## RESPONSE TO REQUEST FOR ADDITIONAL INFORMATION

### APR1400 Design Certification

Docket No. 52-046

RAI No.: 61-7984  
SRP Section: 08.03.01 – AC Power Systems (Onsite)  
Application Section: 8.3.1  
Date of RAI Issue: 07/06/2015

< The mobile generators are connected to Class 1E power distribution system train A or B.>

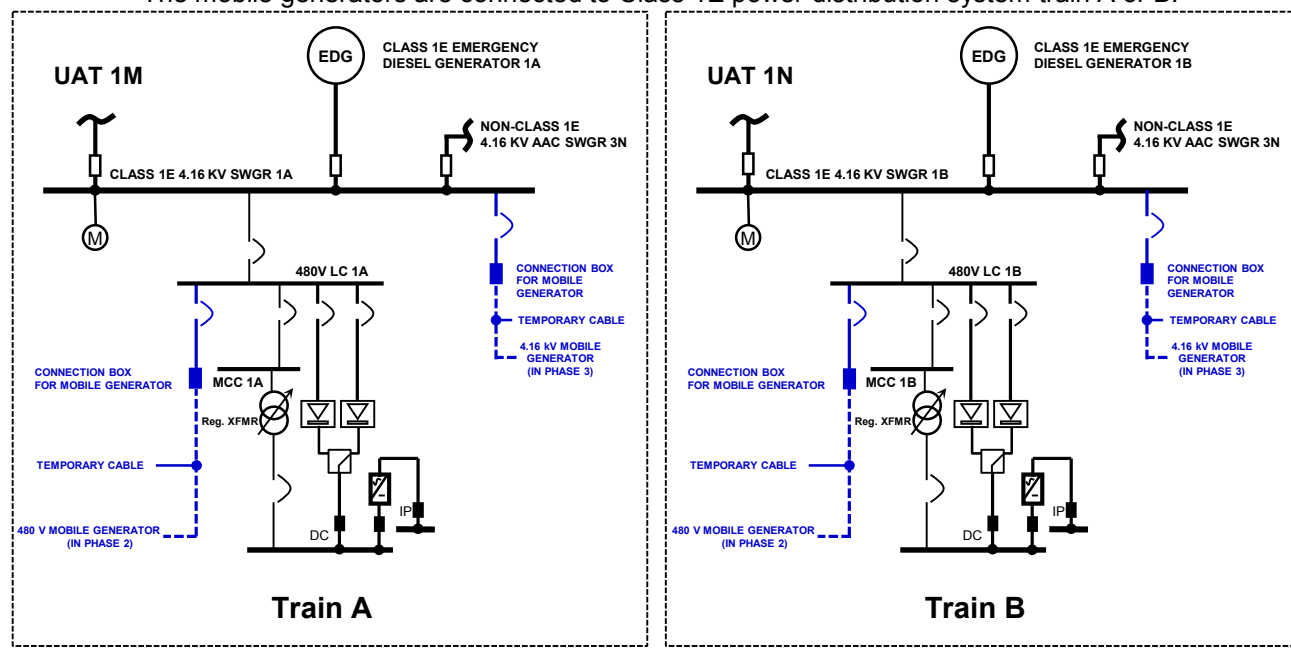
Provide a summary of the design aspects of the mobile generator, including anticipated physical location, connection configuration, the method of transferring the source to safety buses, specification of the equipment, details of support equipment.

Class 1E loads are divided into two redundant load groups (Divisions I and II). Each division has two independent subsystem trains: trains A and C (Division I) and trains B and D (Division II). The mobile GTGs are connected to the Class 1E power system train A or B at each phase of the mitigation strategies for BDBEEs.

- Phase 2 : 480V mobile GTG connected to the LC bus
- Phase 3 : 4.16 kV mobile GTG connected to the SWGR bus

The mobile GTGs supply power to the Class 1E bus through connection boxes. Power cables between the connection boxes and the incoming circuit breakers of the Class 1E buses are permanent installations. Connections between the mobile GTGs and the connection boxes are implemented by temporary cabling.

To illustrate the preceding, a simplified single-line diagram is provided below.

Figure 8.1-1 Electric Power System Single Line Diagram (Division I) (1 of 2)

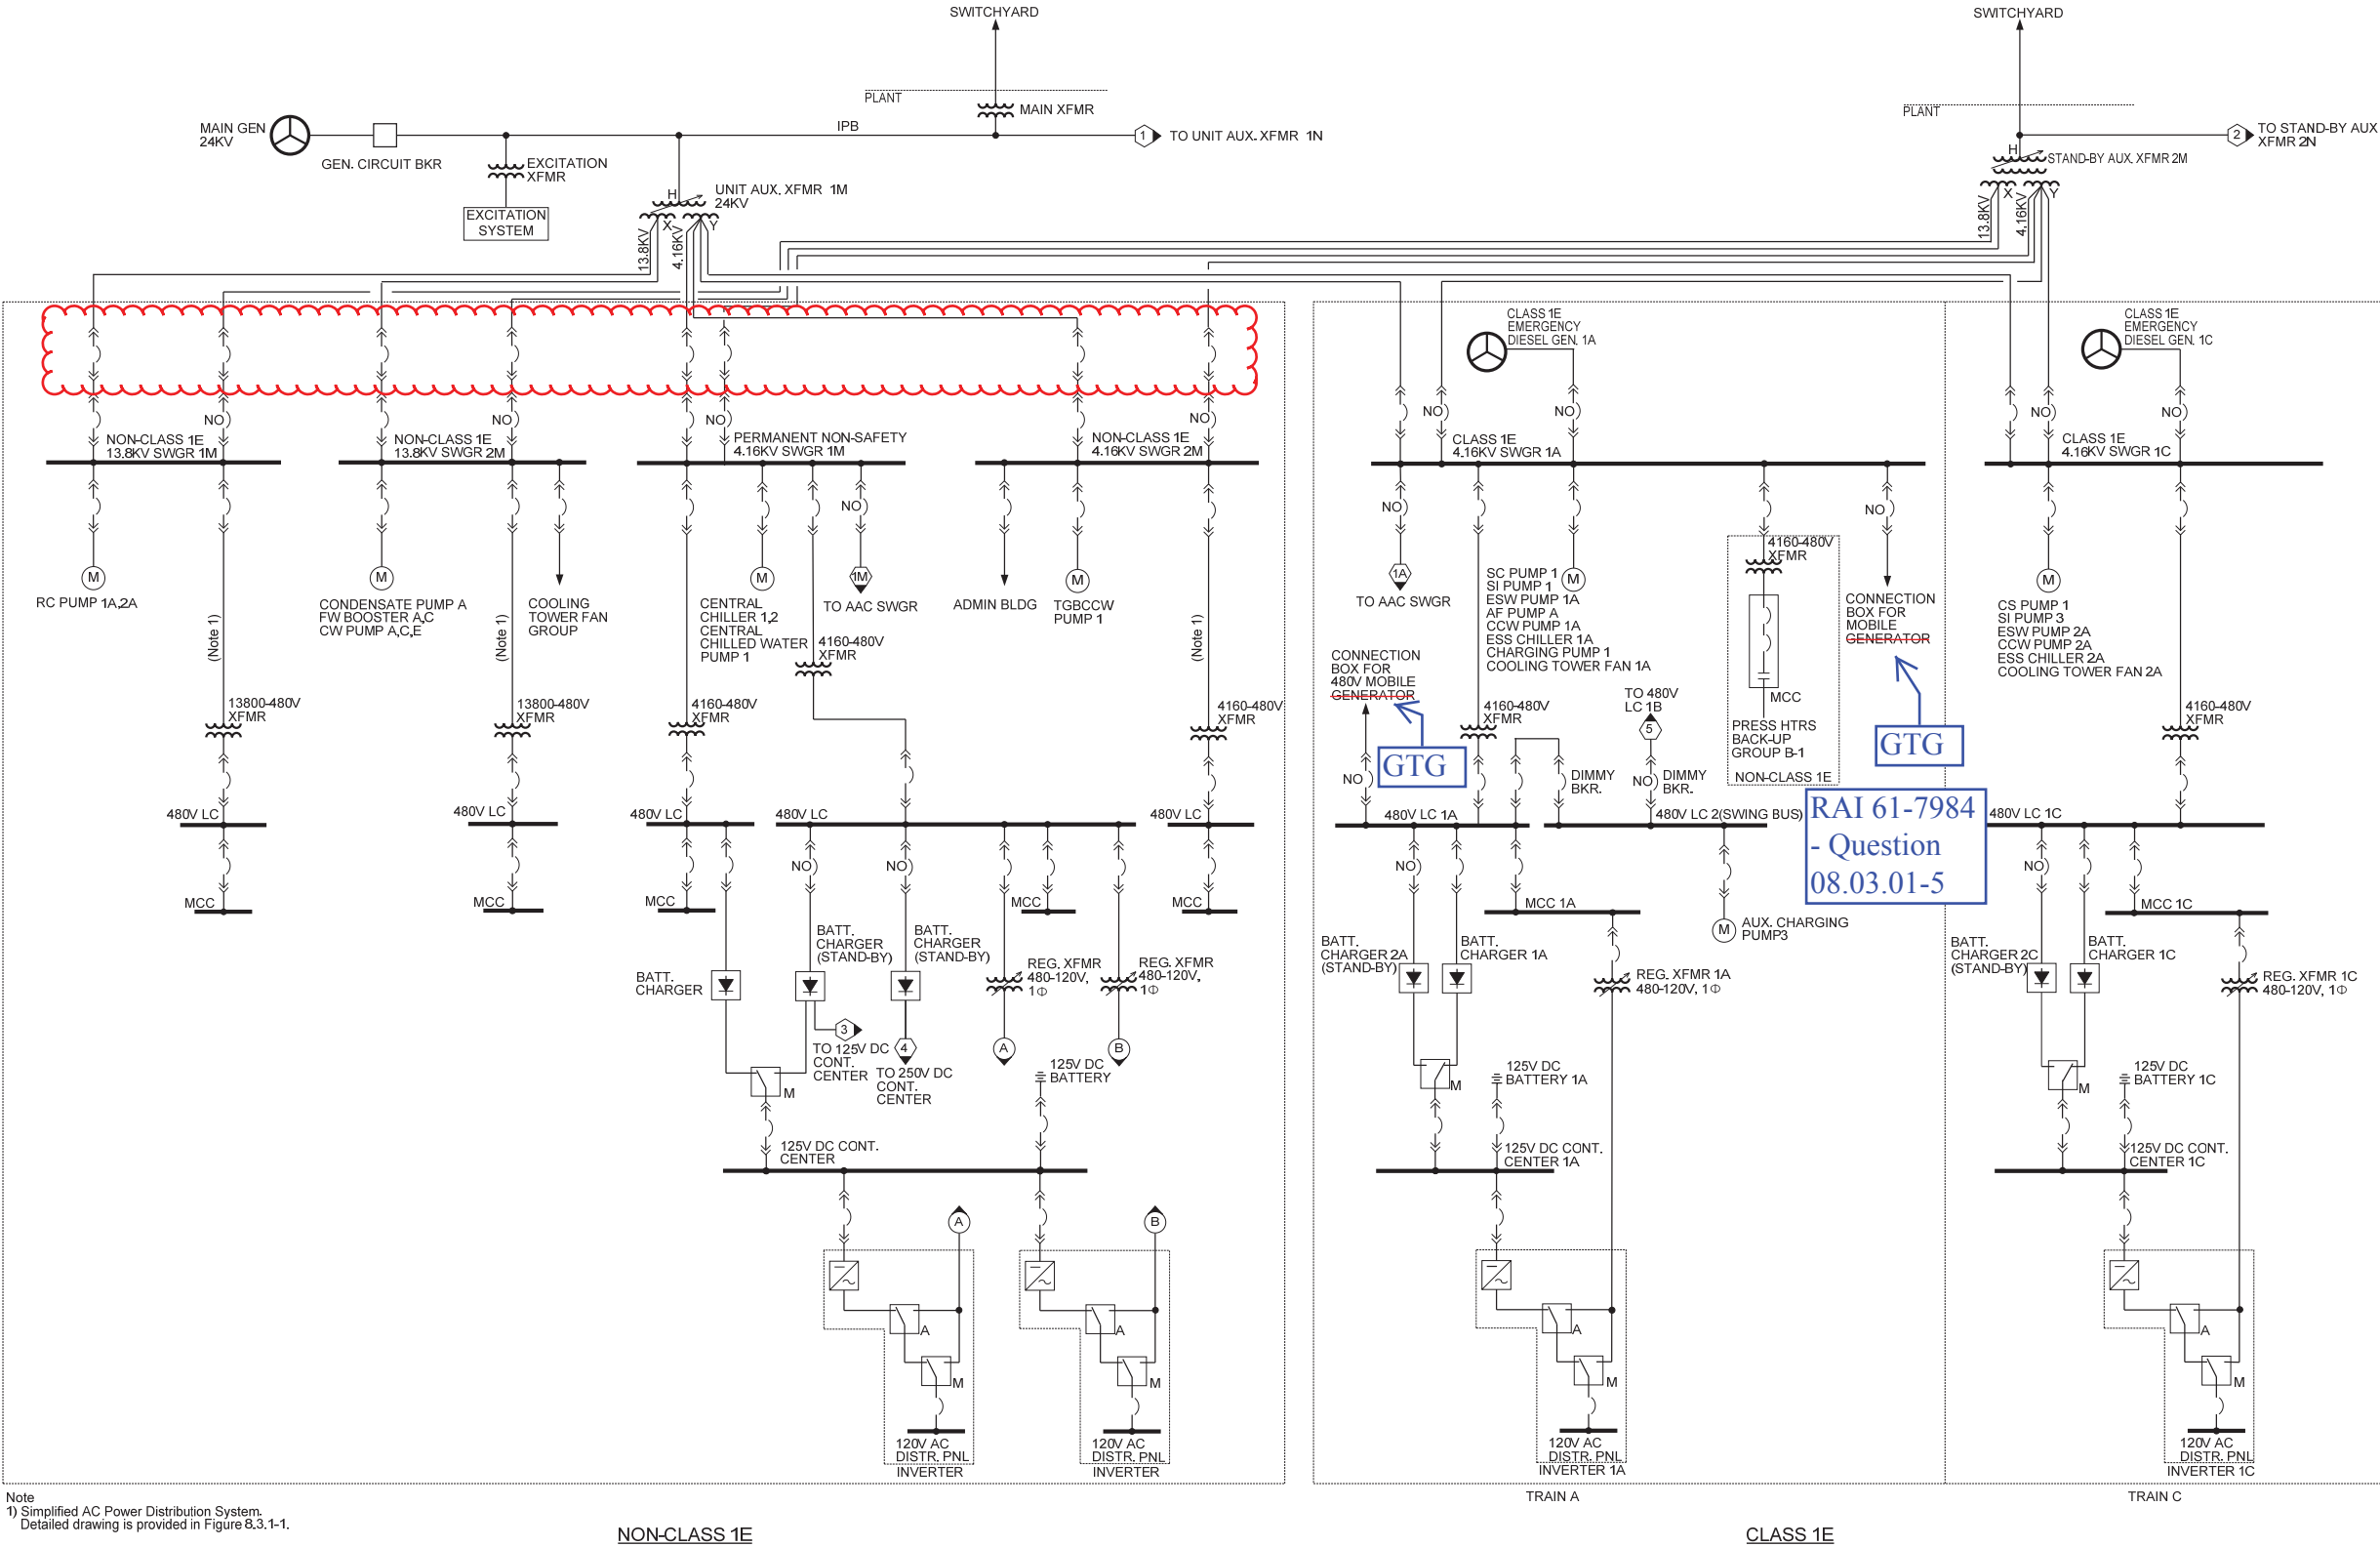
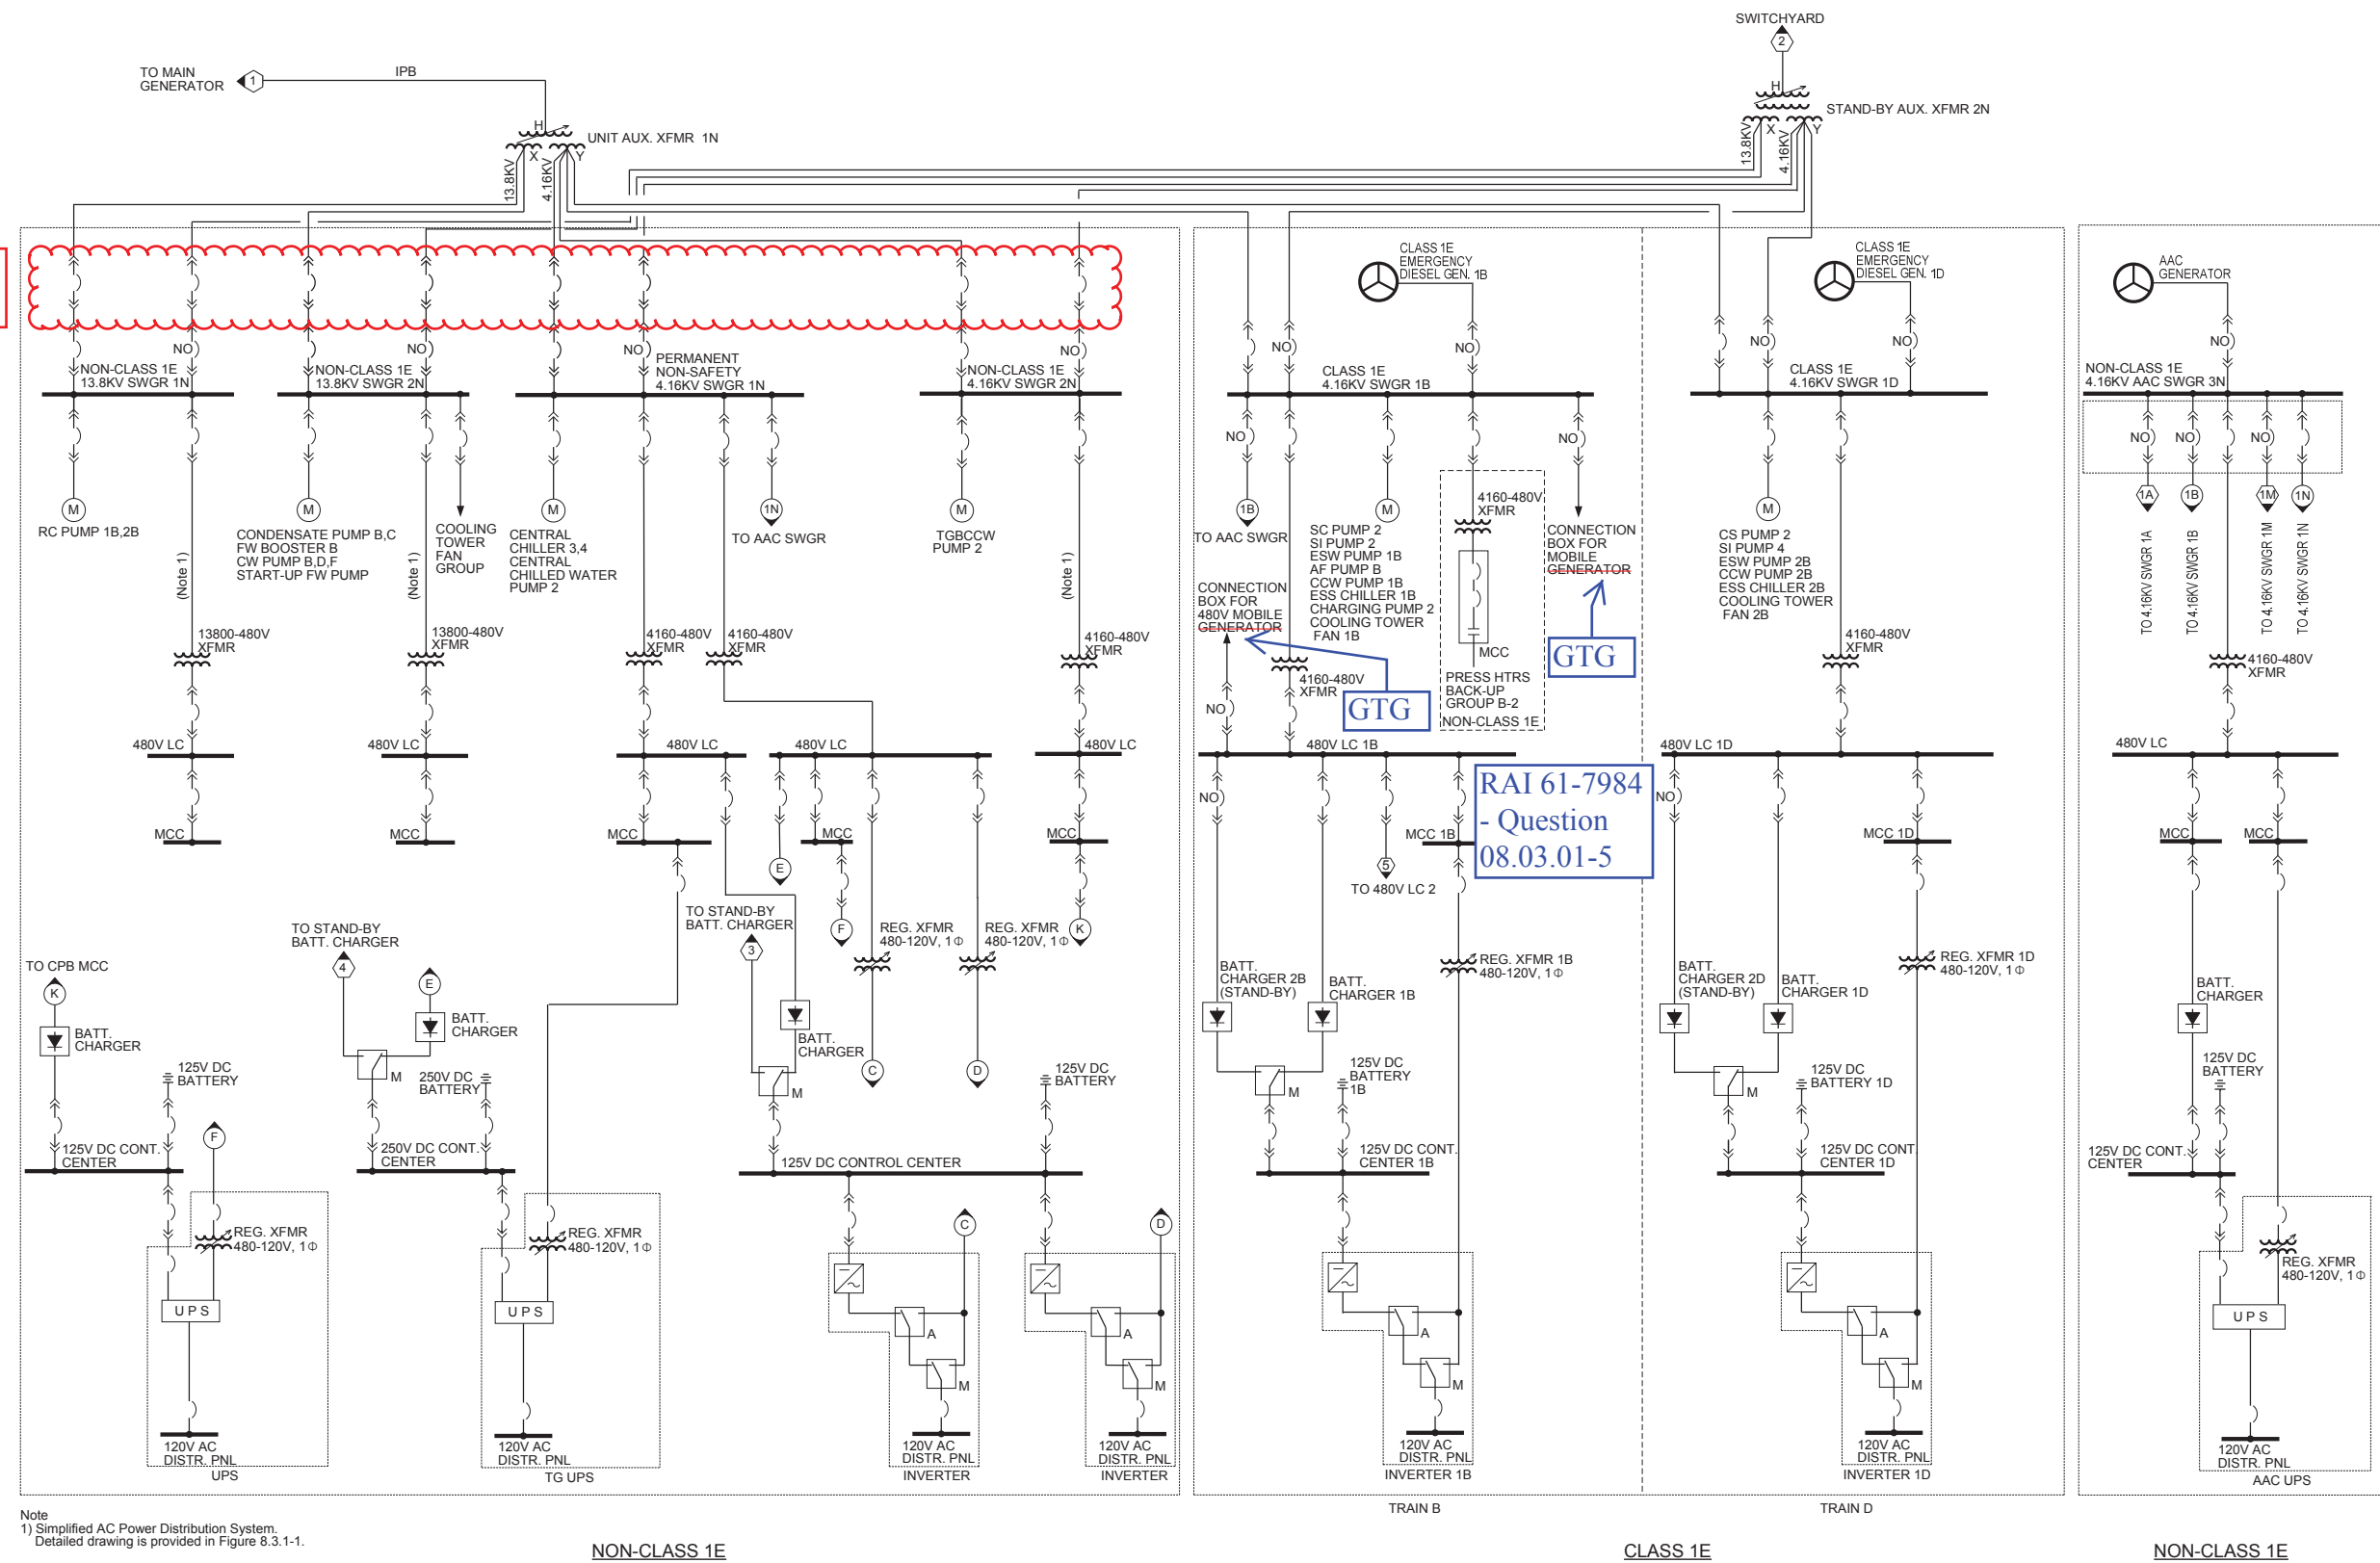
DCD Tier 2 Figure 8.1-1, Section 8.3 and Figure 8.3.1-1 will be revised as shown in the Attachment.
